We would like to object to planning application 22/01163/FUL for Lidl at St Mary's Gate proposals. There are five design issues we wish to highlight to officers and members. This is concerning the significant detrimental impact the proposed development will cause on a key section of Sheffield's walking and cycling network, the Cycle Ring Route.

1. Eyre Street Entrance – Cycle Ring Road Crossing

Figure 1 08/04930/FUL – Approved Site Layout showing Cycle Ring Road Crossing

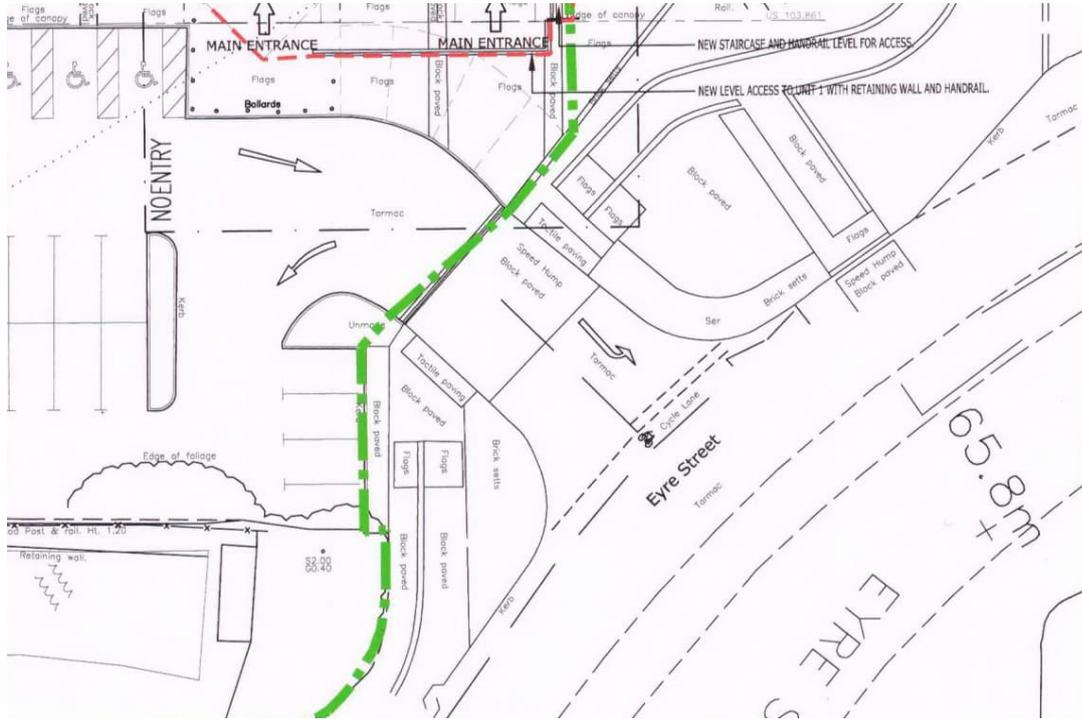
The Eyre Street entrance is crossed by the setback, Cycle Ring Road segregated cycle track and pedestrian footway. This is shown in Figure 1, taken from previous planning applications. The current applicant fails to acknowledge this crossing in planning drawing.

In order to meet LTN 1/20 Cycle Infrastructure Design Standards, the junction of Eyre Street and the site entrance needs to be upgraded. This is also reflected in the recent revision of the Highway code which sets Pedestrians and Cyclists above motor vehicles in the vehicle hierarchy. Highway Code H2 also makes very clear that Pedestrians and cyclists have priority at junctions. This should be reflected in the “improved junction” designs by the applicant.

We would like to see officers advise that in the interest of public safety, this crossing is upgraded to meet modern standards and highway code priority changes.

We strongly urge officers to secure this by condition to ensure safety for vulnerable users and achieve compliance with national guidance.

Figure 2 – LTN 1/20 Side Road Treatments

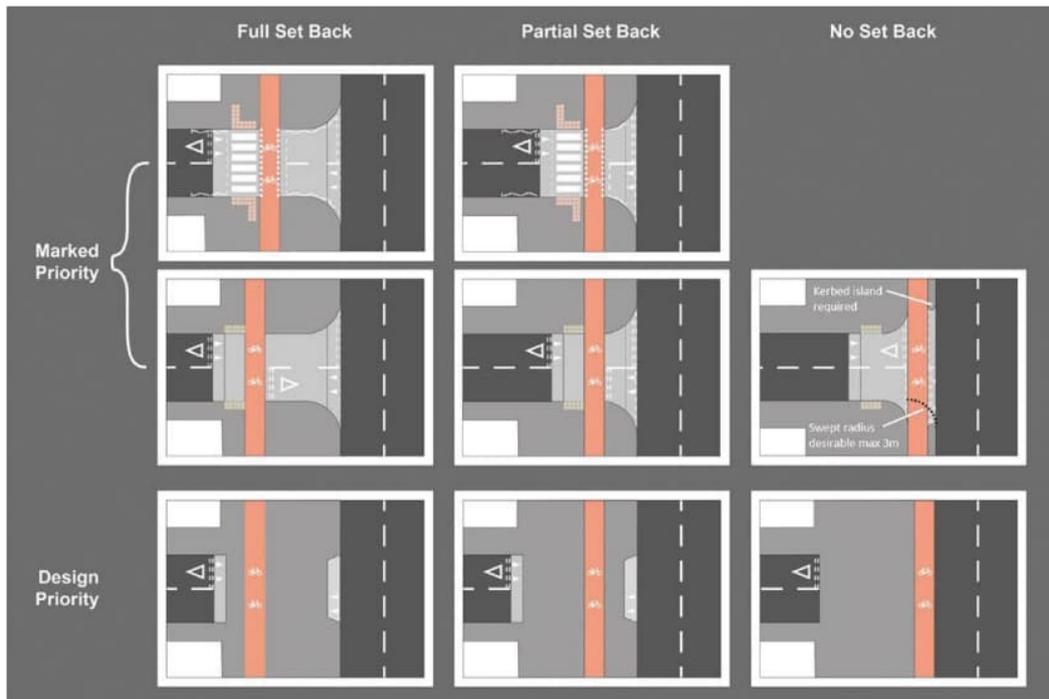
The required design is shown in Figure 10-3 of LTN1/20 and has been presented in Figure 2. The existing layout already features a “full set back” crossing but clear priority for active travel users is needed.

Figure 3 Proposed Cycle Parking

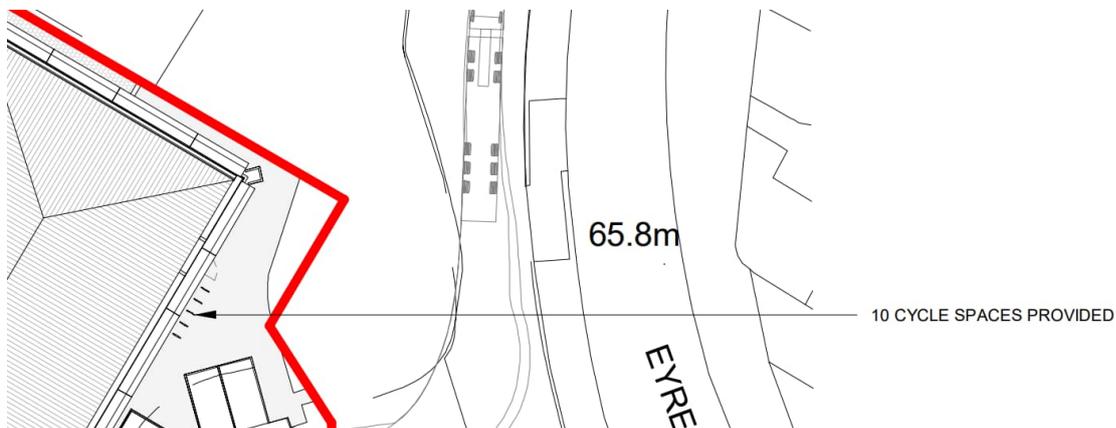
Cycle Sheffield welcomes the provision of 10 Sheffield Cycle Stands which appear to be under the shelter of the existing canopy for use by the public. (Figure 3)

Can the applicant or officers please clarify if the sheltering will be retained as part of the building alterations.

It should also be conditioned that these cycle stands are secured into the floor via concrete footings, rather than bolting down which is a security risk, as identified by the Sheffield Cycle Parking guidance.

Cycle Sheffield objects to staff being advised to use this cycle parking which is unsecured, and provision should be made within the building or a secure outdoor compound, fenced in. This is against the guidance shown in Figure 4.

Figure 5 Existing South Street Layout

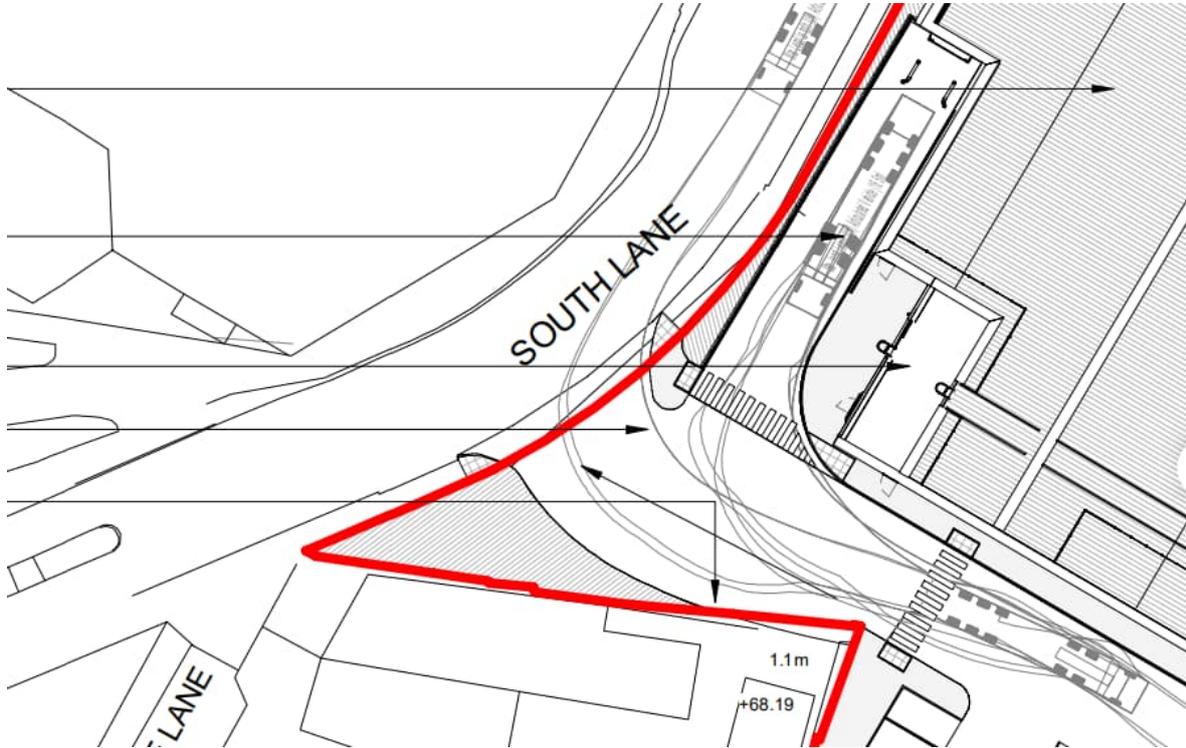
a. The applicant is proposing a new access point along South Lane, at the current location of the servicing yard. The existing layout is shown in Figure 5 and the proposed layout in Figure 6.

While infrequent HGV access along South Lane is considered to be acceptable, the proposed left turn for car drivers from the car park on to South Lane is not acceptable in its current arrangement.

Cycle Sheffield in its role as a champion of walkers & wheelers has issues with the use of a new left turn on to South Lane without mitigation measures or banning this left turn for car users.

Similar to the previous comments about Eyre Street, Highway Code Rule H2 states “At a junction you should give way to pedestrians crossing or waiting to cross a road into which or from which you are turning.”. If egress from the site is allowed here, mitigation should be added in the form of a zebra crossing, to reinforce pedestrian priority, at top of the road user hierarchy.

Figure 8 Connecting Sheffield – South Lane arrangement

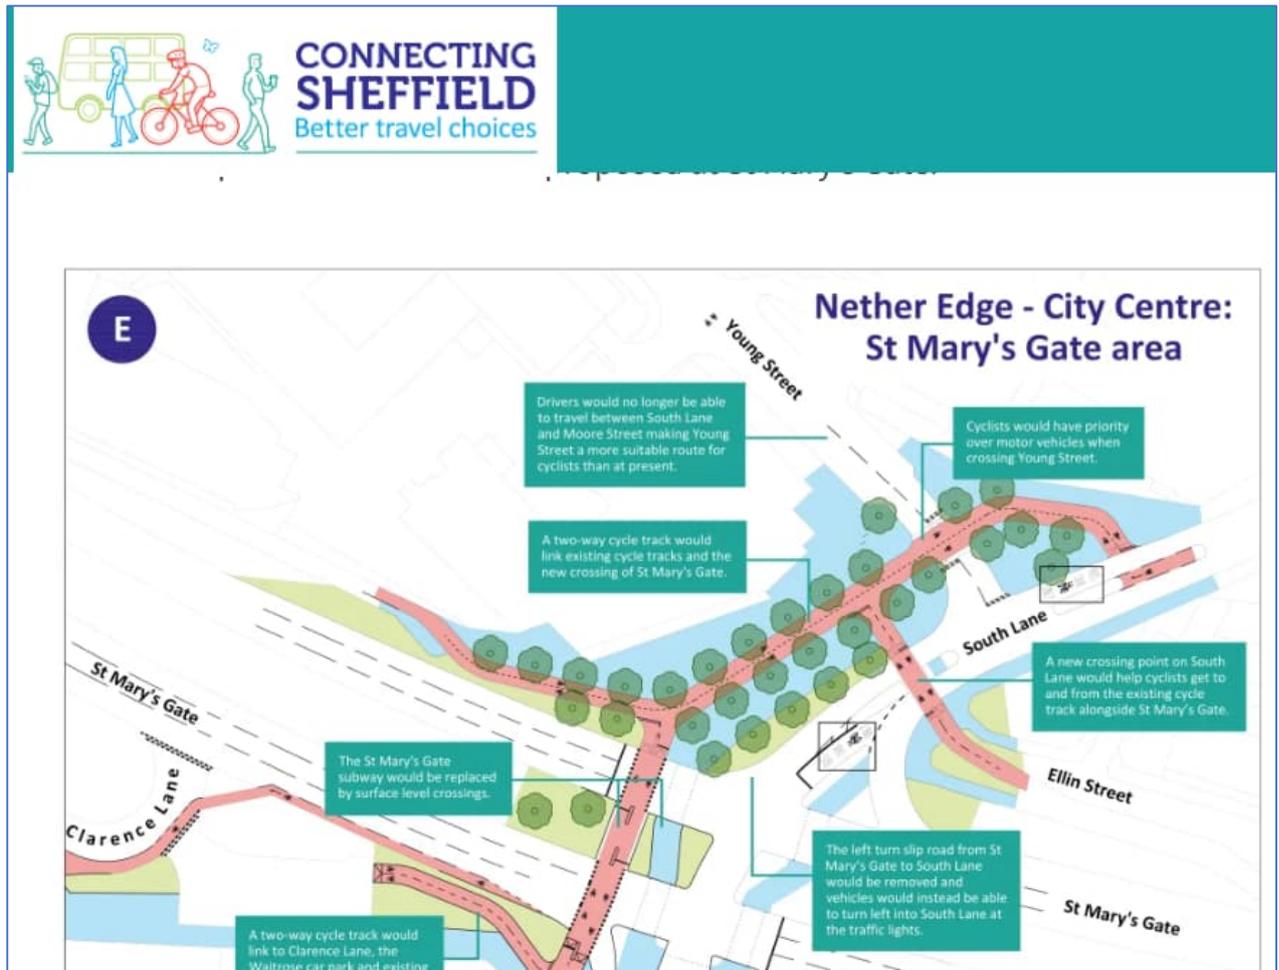
c. Further to these comments around pedestrian priority, the applicant has not considered the impact of the Connecting Sheffield Nether Edge scheme (Figure 8) which will be constructed before the Lidl store is opened to the public. Please ask the applicant to demonstrate awareness of these proposals and mitigate accordingly. A sensitivity test including the revised London Road junction would be beneficial.

Figure 10 – Proposed Drop Kerb- Street View

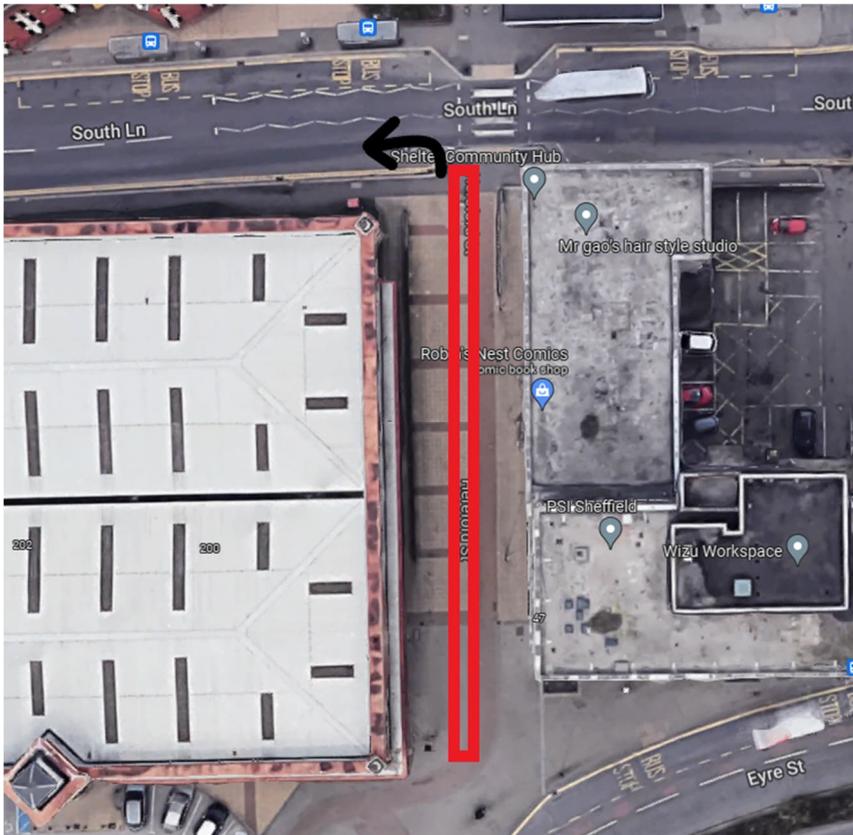
We propose that Lidl should provide a drop kerb at this location, to allow cyclists to turn left on to South Lane, bypassing the zebra crossing. This is demonstrated in Figure 10 & Figure 11

The provision of a single drop kerb is a proportionate and appropriate design response.

Figure 12 – Existing Conditions

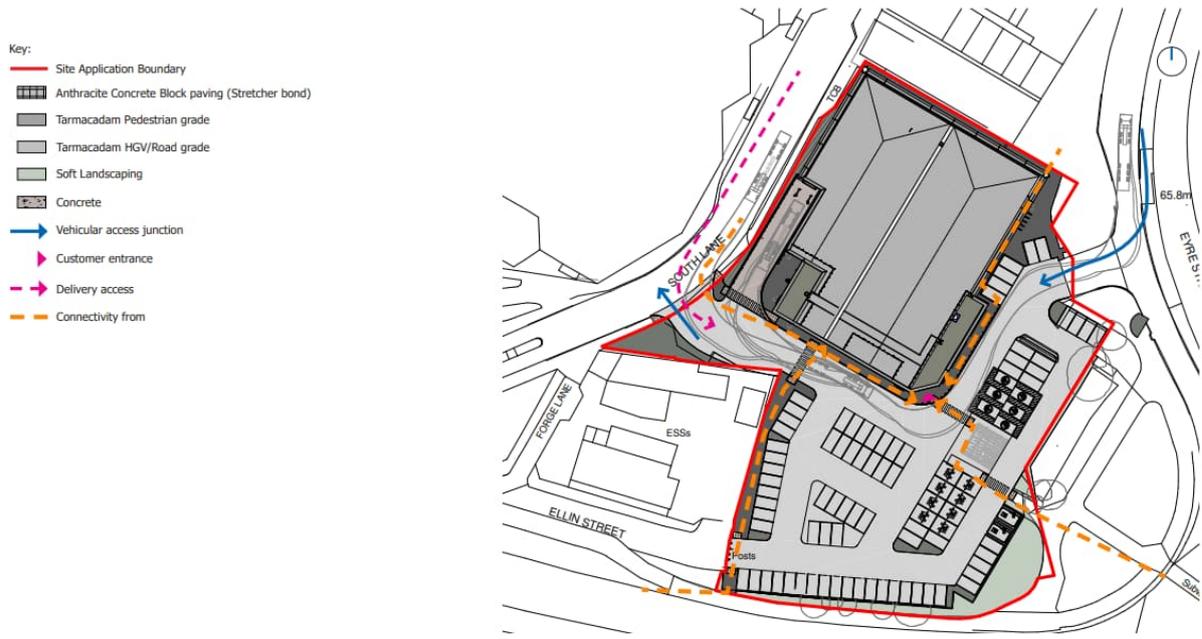
The Planning statement marks an access route from Eyre Street heading southbound, right turning into the site. This appears to be an error which requires correction.
